# The Report

House No 9

This report systematises and organises the numerous construction and workmanship errors occurring in the private residential house located in Lote 3 - Casais Porto Dinheiro.

## 1.1. Drains and gutters

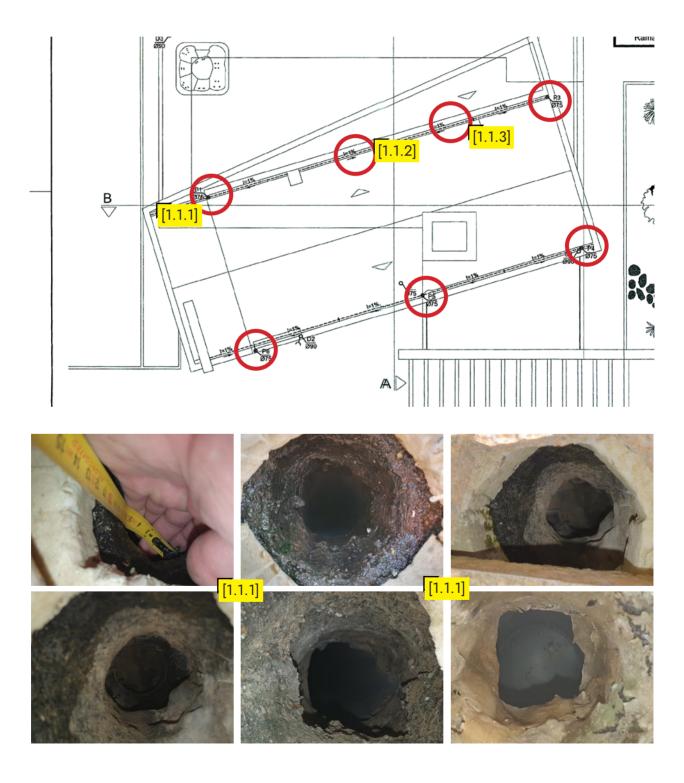
**1.1.1.** All the drains from the roof are of insufficient diameter.

In the design, the drain diameter was specified as 75 mm, while in reality the drains have a diameter of less than 50 mm (their diameter was reduced by the layers of roofing felt rolled inwards).

1.1.2. There were also no middle drain holes (P2 and P5) which are present on the building design.

## 1.2. Fireplace chimney

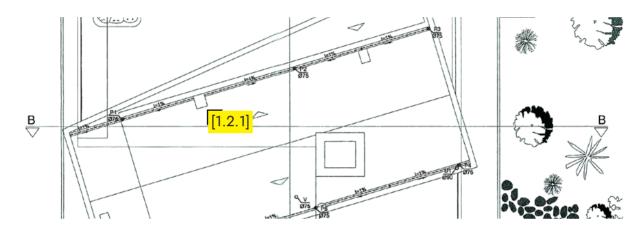
1.2.1. The chimney flue is made of spirally wound galvanized pipe (SPIRO), the use of which is prohibited for solid fuel combustion fireplaces!

There is a serious risk of thermal damage to the pipe and the release of toxic exhaust gases into living spaces.

1.2.2. The chimney cap was made incorrectly. It has the form of a concrete slab mounted on 4 posts. The clearance between the cap and the chimney is created by very small gaps, thus limiting the chimney draft! Both the smoke and ventilation chimneys are too short. Significantly shorter than on the building design.

## 1.3. Cracks and other defects

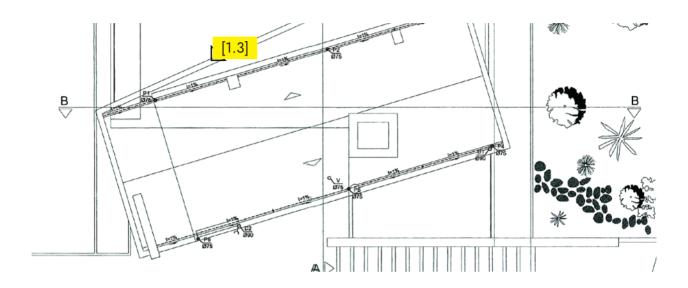
**1.3.** The roof attic walls have copings made of stone, with many defects also lack of the grout on connections. Cracks and leaks in the copings joints promote the nesting of vegetation, resulting in further degradation.

## 2.1. The drainage

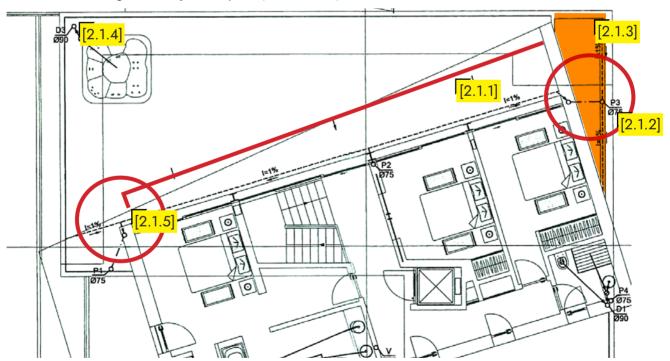
- **2.1.1.** The terrace drainage trough is not located in accordance with the building design.
- According to the building design, the terrace should have a slope towards the wall. Instead, a drainage trough was laid diagonally across the centre of the terrace surface.

- Its inlet is only a few millimetres wide. The walls and the bottom of the trough are simply concrete of the screed the trough is in no way protected by a system insert or other barrier to prevent water from seeping into the screed under the tiles.

- **2.1.2.** The northern end of the drainage trough was not connected to drain P3 as shown on the building design. The drain marked on the building design as P3 is not connected with the terrace outlet at all. A drainage grate for indoor use is employed, which causes its significant degradation under the influence of environmental factors and results in frequent blockages.

- 2.1.3. Furthermore, the drainage trough at P3 cannot serve as a support for the terrace drainage, as the part marked in orange is about 8-10 cm higher than the rest of the terrace!

## 2.2. The covering

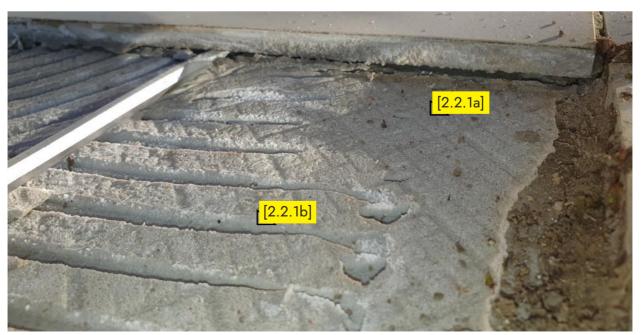
The terrace covering was made of ceramic/gres tiles, attached by adhesive mortrar. The majority of the tiles are hollow - detached from the screed, and in places the tiles stand out clearly from the terrace plane. A significant number of joints are cracked, cracks and cavities are visible.

Total lack of expansion joints, which causes the joints between the tiles to crumble and the tiles to detach from the substrate.

#### 2.2.1. Defective terrace covering.

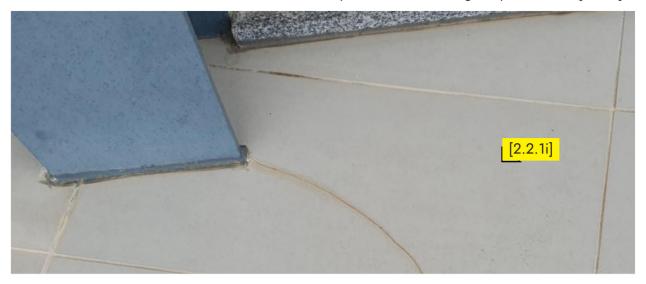
The tile was very poorly bonded to the screed and was easily removed when levered. The adhesive mortar is not bonded to the tile over a significant area [2.2.1a]. Insufficient adhesive and voids between the adhesive layer and the tile are revealed [2.2.1b].

Numerous tiles are defectively laid, their edges standing out from the surface. [2.2.1c].

No waterproofing was found to protect the screed from water penetration [2.2.1c]. The only insulation against the water is the tar fabric on the concrete slab. This causes all the above layers to be penetrated by the rain water sipping thru the grout cracks.

The concrete screed is yellow in places, very crumbly and resembles wet sand in texture. [2.2.1d].

## 2.3. Grouts and seals

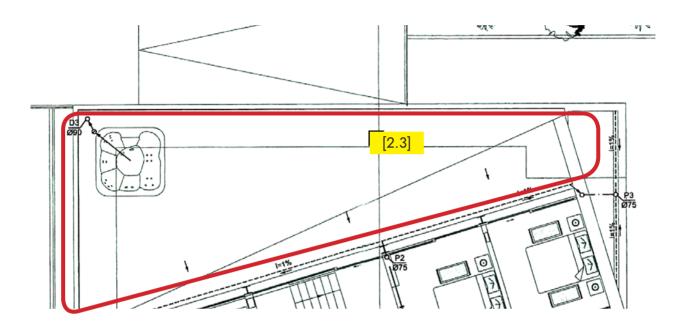
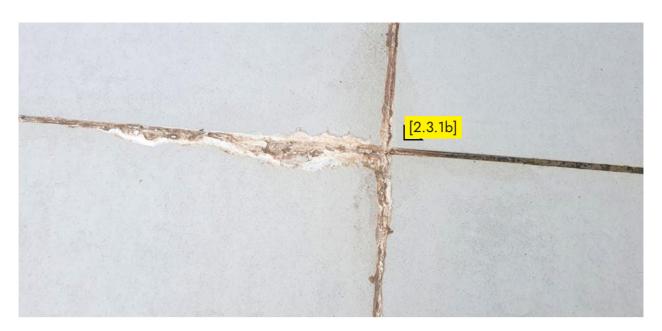
**2.3.1.** Numerous cavities and discolouration in the tile grouts were found on the overall terrace surface. There are many visible instances of grout erosion [2.3.1a].

The connection between the terrace surface and the balustrade is cracked or absent in many places. This creates the possibility of water penetrating into the balustrade attachment points and further erosion. The connection between the balustrade and the terrace should be both watertight flexible.

**2.3.2.** Some joints show signs of repair and sealing. These are ineffective treatments because the wrong technology and materials were used. Significant degradation of repaired joints can be seen.

#### **3.1.1.** Improperly constructed rainwater drainage from balcony.

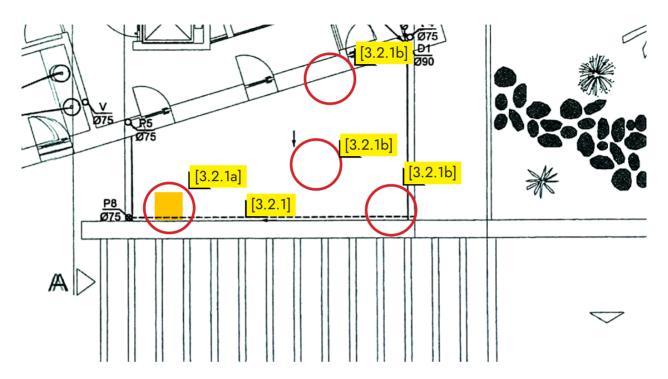
The diameter of the P8 drain pipe is 50 mm whereas by the building design it should be 75 mm. In addition, the P8 drain has been placed behind the chimney of the grill located on the patio below. This location of the drain results in the accumulation of debris and plant elements and makes cleaning the drain much more difficult. It should be mentioned that the grill chimney (highlighted in orange) is not present in the building design. [3.2.1a].

Cracks in the masonry fence of the balcony [3.1.1b].

Degraded grouts [3.1.1c].

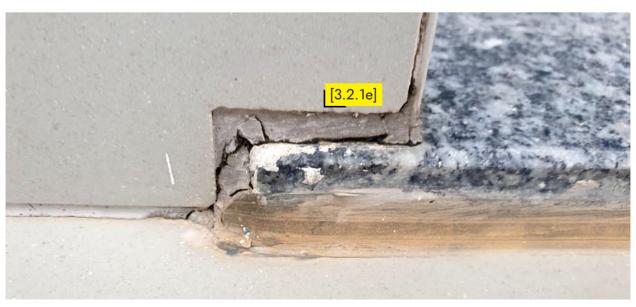
Rainwater deposited on the balcony as a result of incorrect surface profile [3.1.1d].

Cracks at the junction between balcony and house wall [3.1.1e].

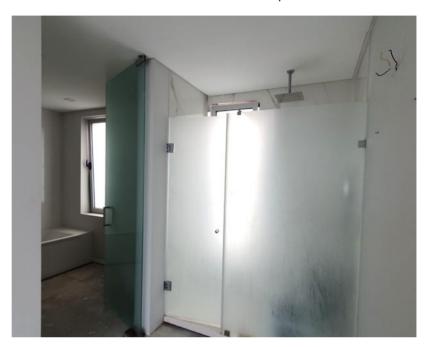
3.3.2. The bedroom on the south side has developed leaks around the patio window. The window frame was covered with green algae, there was water in the floor and in the window frame. The skirting board is slightly swollen from the dampness.

## 4.2. Kitchen hood connection

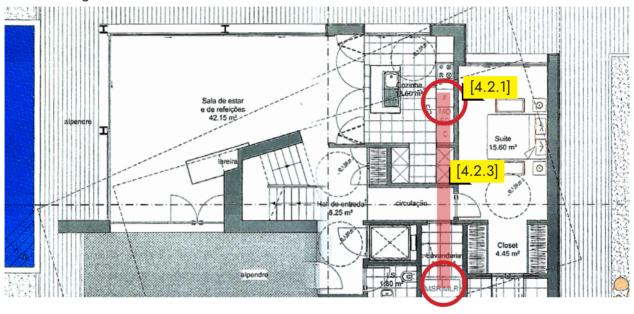
## 4.2.1. The cooker hood was not connected to the ventilation duct!

The pipe from the cooker hood was led into the space between the concrete slab and the false ceiling [4.2.2]. A few metres of ventilation pipe are missing between the cooker and the ventilation duct [4.2.3].

All cooking fumes, odours and moisture are introduced into the hollow space below the false ceiling and spread throughout the flat.

## 4.3. Water-catching contraption

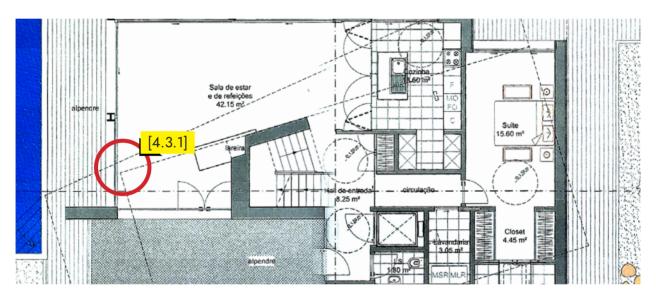
**4.3.1.** In the south-east corner of the living room, a specific structure was detected hidden above the false ceiling. It consists of a metal tray partly suspended from the ceiling and partly lying on the frame of the suspended ceiling. There is also a tar paper apron attached to the ceiling using a metal profile and supported by a wooden pole made from a cut-off brushstick.

The whole thing is located underneath where the roof and terrace drainage pipes pass through the terrace ceiling.

Presumably this is a device to catch leaks from the terrace that the contractor could not deal with. Instead of sealing the penetrations through the ceiling and fixing the problem, a leak masking device was installed.

This is an unprecedented, non-technological solution and should not be used in housing.

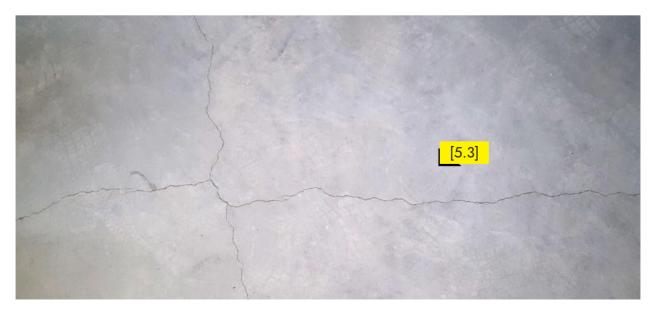
The main problem in the basement is dampness [5.2a]. There are stains on the floor, damp patches on the walls – mainly in inner walls. Poor horizontal damp protection of the floor and walls thus capillary seepage through the walls are responsible for this dampness.

There are also some traces od water soaking the walls in the garage top corner (near the ceiling) [5.2b].

**5.3. Cracked floor**The concrete screed is cracked in many places.

**6.1.2.** Cracks below top of walls and masonry.

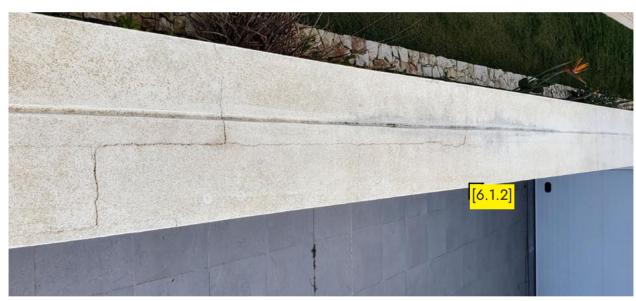
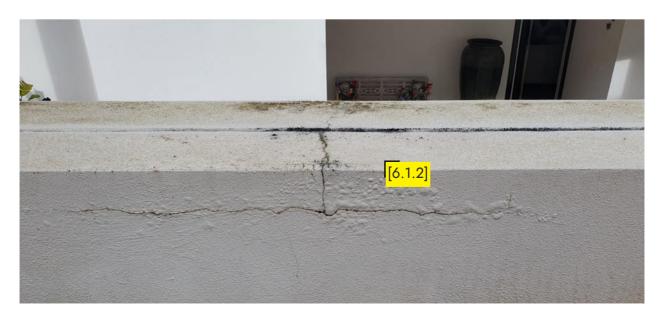
Caused by water penetration due to missing or poorly executed copings, wall settlement and stresses arising at the boundary between different materials.

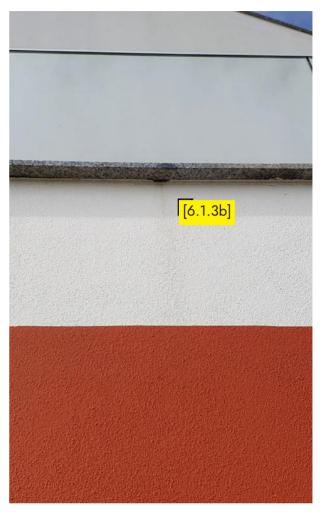
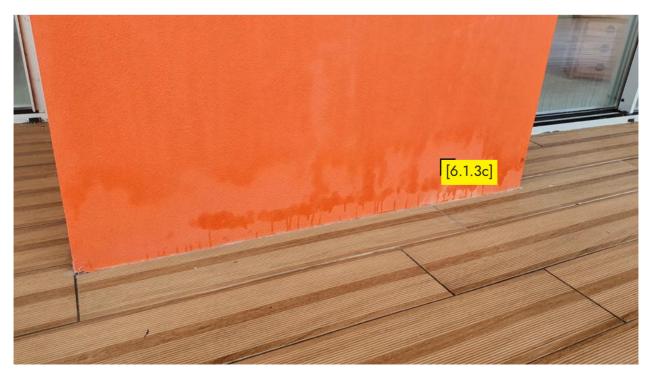
- **6.1.3.** Discolouration and staining on the facade.
- **6.1.3a** This is a possible exudation of water from a leaking balcony.
- 6.1.3b Staining from rainwater due the lack of throating (drip channels) in the copings.
- **6.1.3c** Stains from rainwater sipping up from the patio floor.

#### 7.1. Patio profile and drainage

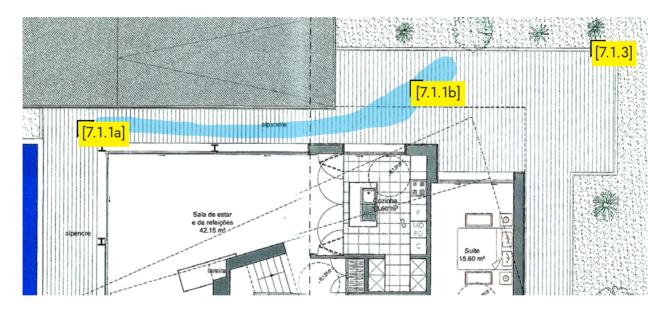
Patio surface on wrong profile – it forms a trough, there is no slope [7.1.1a] or even worse - the slope is slightly to the bulding direction [7.1.1a]. As a result, rainwater floods the patio in puddles [7.1.2]. Excess water running off the patio is not drained anywhere. It is likely that some of the water flows freely from the terrace near the wall and infiltrates into the garage - hence the stains in the corner under the ceiling [7.1.3], and some run off at the edge of the patio and pool, as well as in the area of the underground pool pump room.

7.2.3. Extreme negligence in sealing the patio windows.

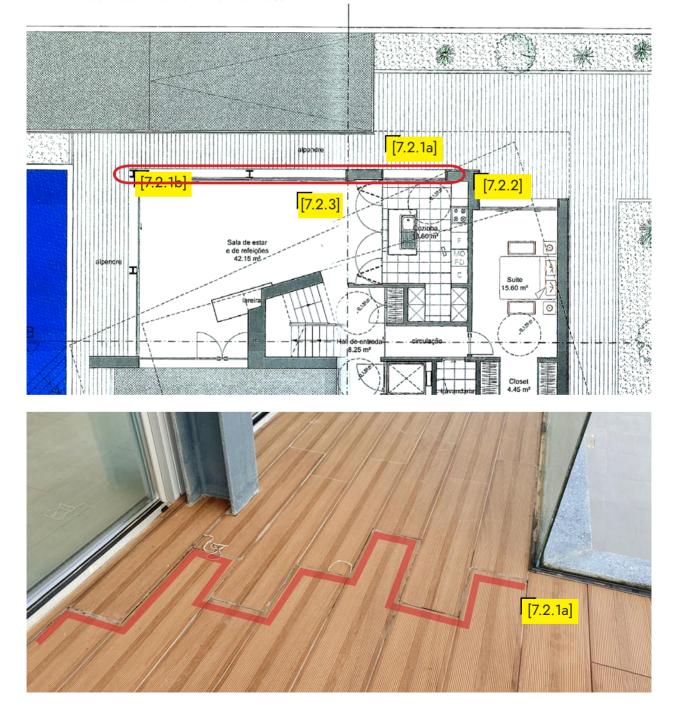
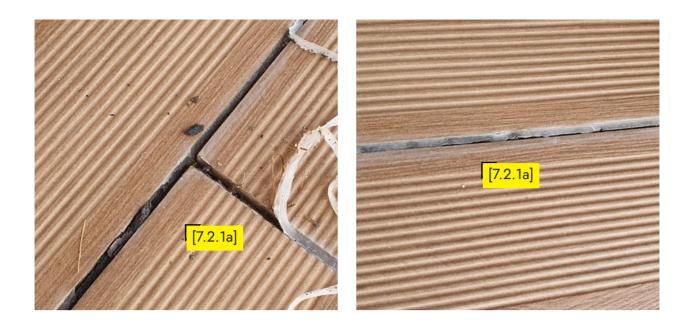
7.2.3 The sealing of the window openings is done extremely carelessly and in an extremely damaging way. Sealing is missing in all areas where the window drains are located! Thus, all the water that runs off the surface of the windows is introduced directly between the wall and the tiles!

There is a lack of tile sealing directly under the water outlets of the window frames, where most water flows out.

## 8.2. The leakage

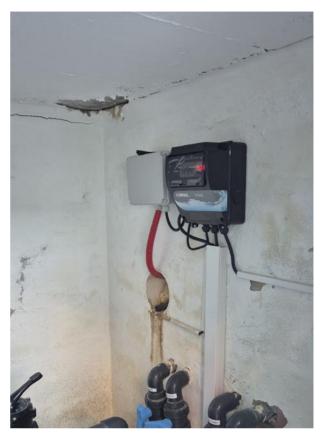
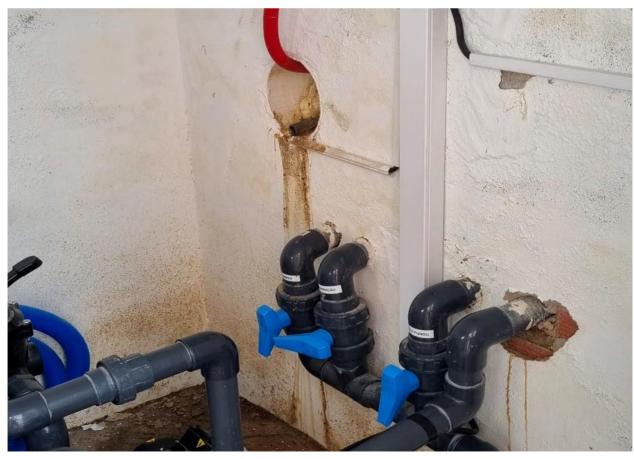
The pool has a leak - water escapes from the pool.

Despite topping up, water reaches at most the first step of the stairs.

#### 9.2. Interior

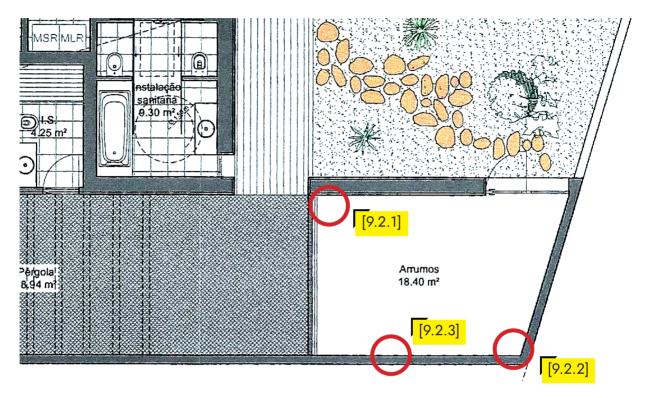
The humidity is high throughout the room and there is a distinct smell of mould. Furniture and furnishings left here are covered in mould and mildew. The covers of the garden furniture have an unpleasant musty smell.

9.2.1. Visible signs of flooding - the rainwater is penetrating from the roof. Fungus and mould developing on the walls and ceiling.

9.2.2. Damp patches on the walls. Green algae growth in plaster.

9.2.3. Crumbling plaster, soggy paint coming off.
